RECEIPT DATE: 12/30/19 **ONSITE SEWAGE DISPOSAL SYSTEM**

PROPERTY ADDRESS: 14041 Howard Road, Dayton

**MEMORANDUM**

**RE: OSDS Plan**  
**14041 Howard Road**  
**Dayton, MD 21036**

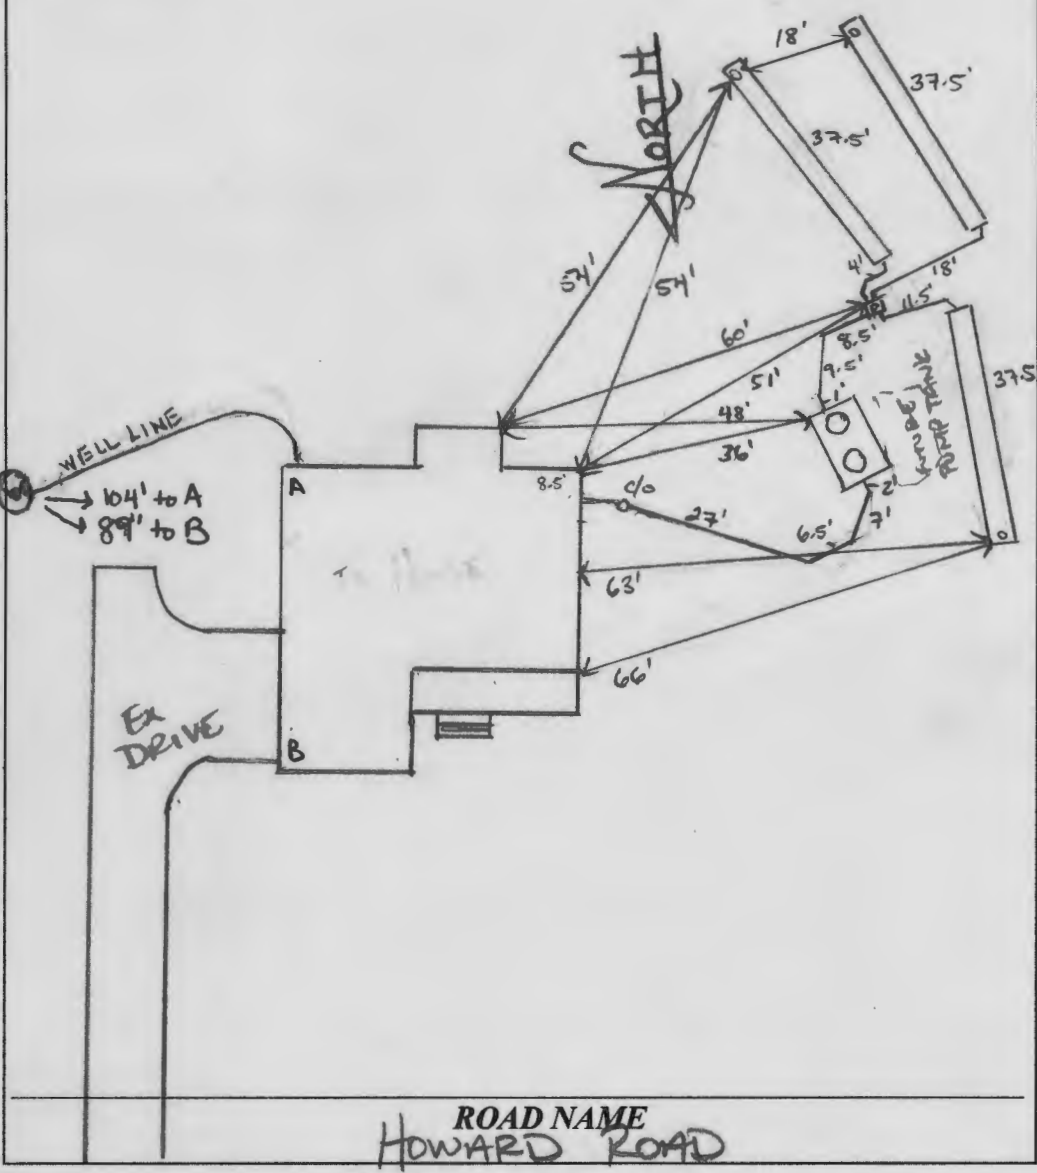
PRE CON: 01/27/2020 MUST STAKE SDA. CALL FOR RE LAYOUT.  
 OK TO SET TANK. (P)  
 ↳ TANK WAS STAKED (P)

01/29/2020 SDA AND TRENCHES STAKED. OK TO START.  
 INSTALLATION:

01/29/2020 LOWER TRENCH AND UPPER LEFT DURING CONSTRUCTION.  
 (P) RAISE LOWER TRENCH TO PERMIT SPECS. (P) 01/30/2020  
 CONFIRMED TRENCH INV, TRENCH BOTTOM (@ 0.85 FEET), (P) TANK  
 SET. (P) D BOX BEING INSTALLED. REINSPECT BAFFLES AND  
 D BOX LEVEL (P) 01/31/2020 D BOX LEVELED WITH SPEED LEVELS. (P)

**WALL CHECK**

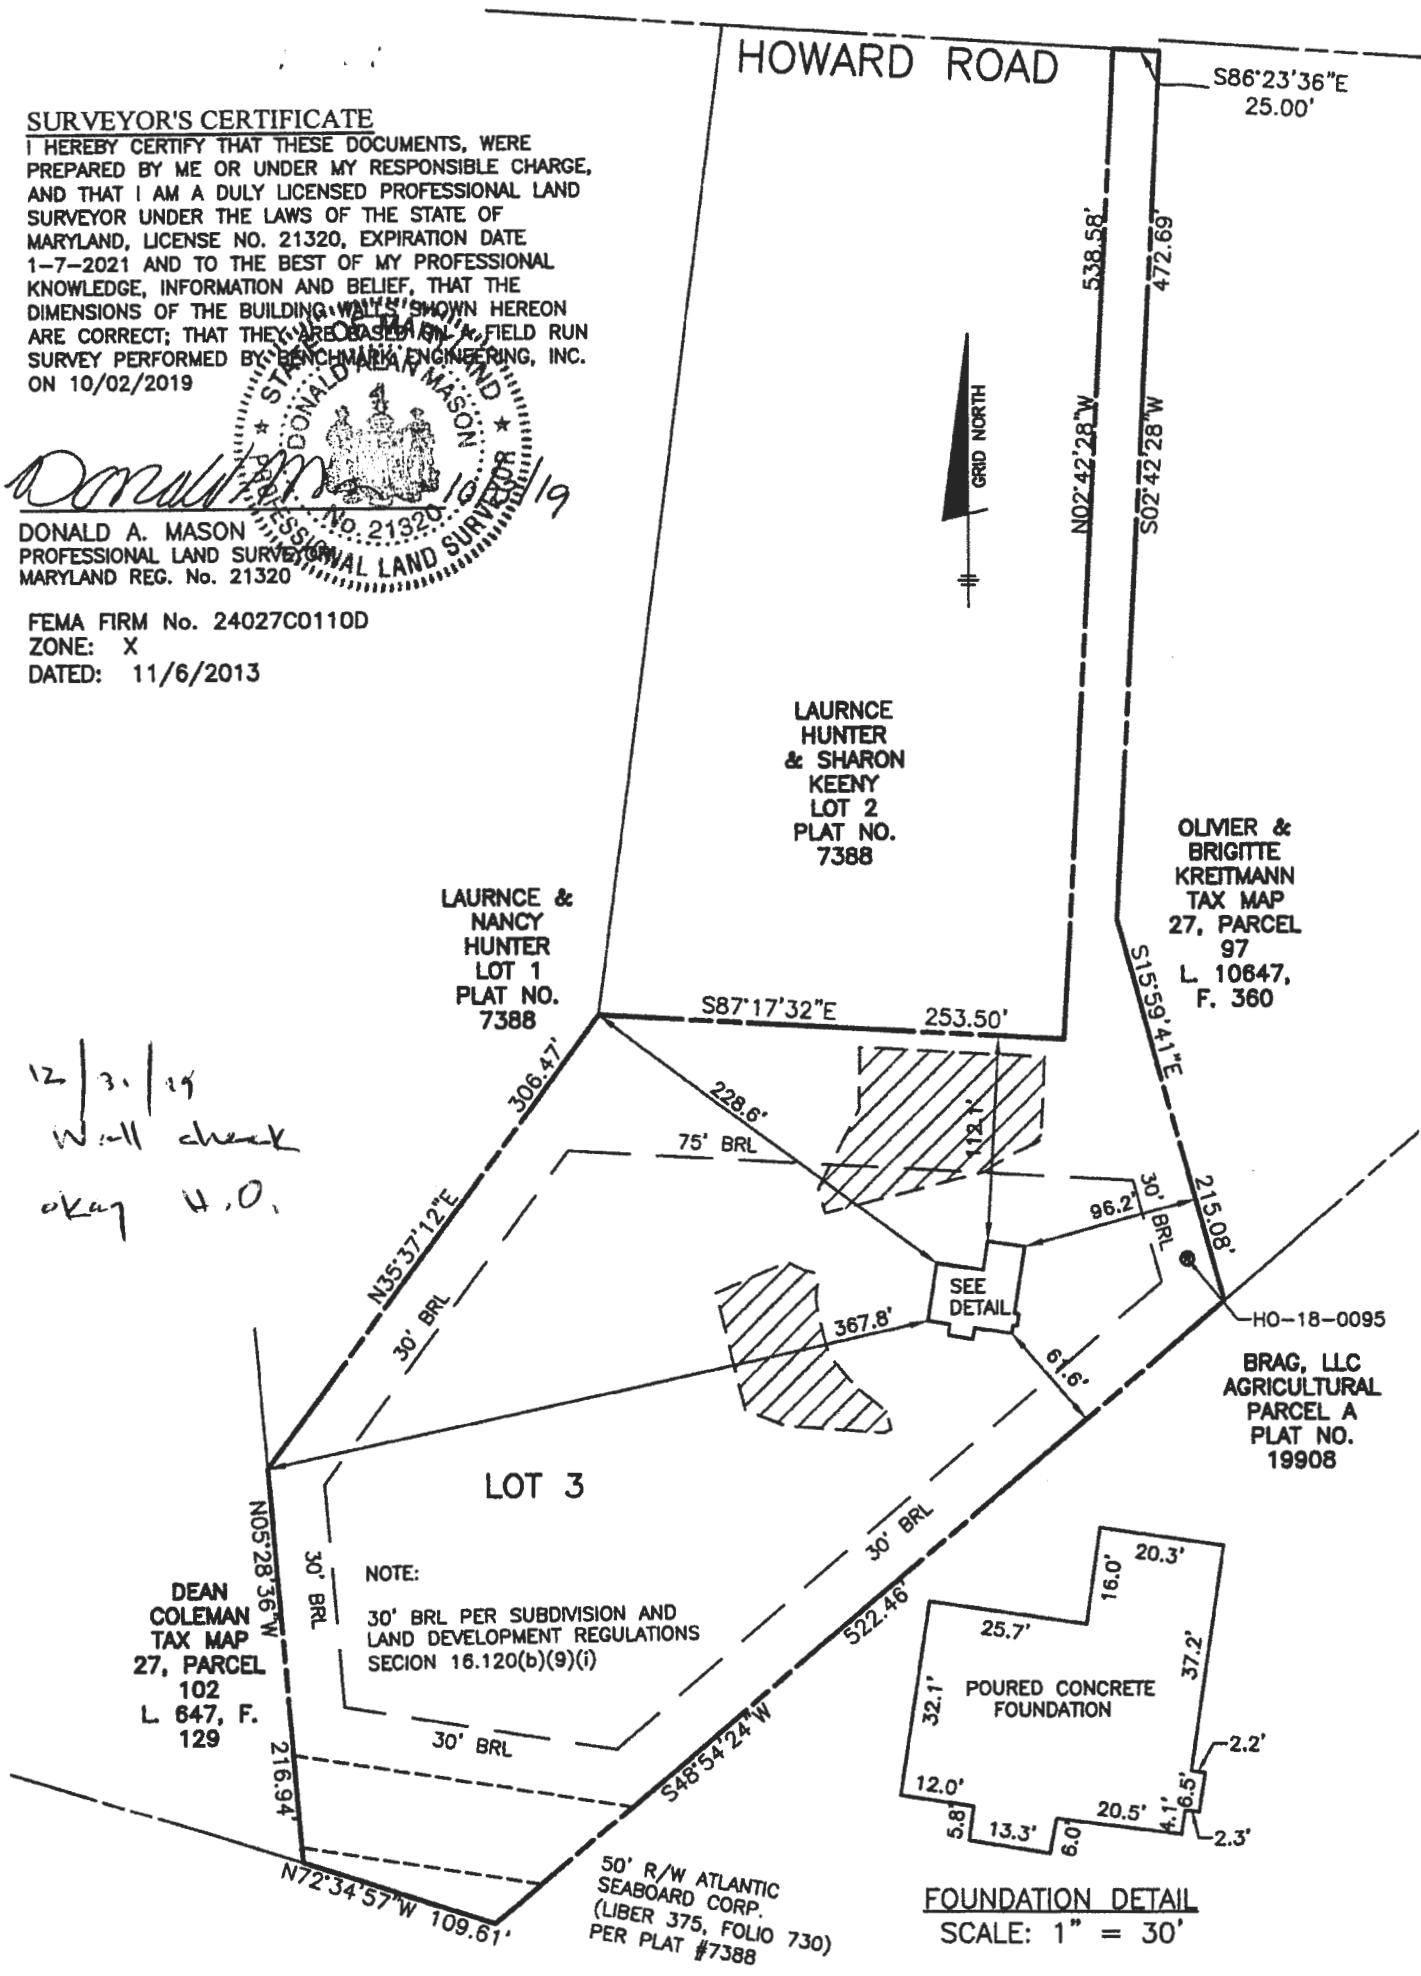
12/31/19  
Wall check  
okay H.O.
